STAFF REPORT		
Address:	3920 Washington Street, Kensington	Meeting Date:	9/20/2023
Resource:	Primary Resource Kensington Historic District	Report Date:	9/13/2023
	Kensington Instoric District	Public Notice:	9/6/2023
Applicant:	Armando Mendoza		
Review:	HAWP	Tax Credit:	No
Kevlew:	nawr	Staff:	John Liebertz
Permit Number	: Pending		
PROPOSAL:	After-the-fact front door replacement.

MONTGOMERY COUNTY HISTORIC PRESERVATION COMMISSION STAFF REPORT

Figure 4: View of the after-the-fact door (left) and 1920 trade catalogue showing a similar front door (right). Source: Applicant and Curtis Companies.

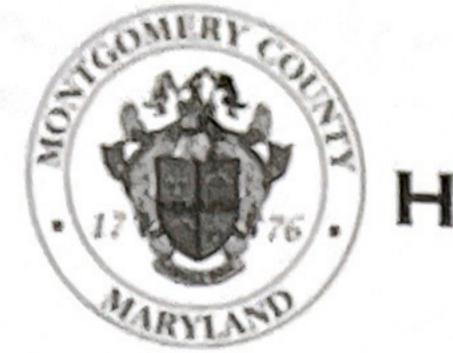
While the new single-light, two-panel, wood (mahogany) door alters the original design, trade catalogues from the early twentieth century include variations of the replacement door for Colonial Revival-styled dwellings (*Figure 4*). Therefore, staff recommends approval of the new door as it is compatible with the historic house and the surrounding district, being a period-appropriate replacement door for a Colonial Revival-styled dwelling.

Staff recommends that the Commission **approve** the HAWP application under the Criteria for Issuance in Chapter 24A-8(b), (1), (2), and (d), having found that the proposal, as modified by the condition, is consistent with the *Vision of Kensington*, and therefore will not substantially alter the exterior features of the historic resource and is compatible in character with the district and the purposes of Chapter 24A;
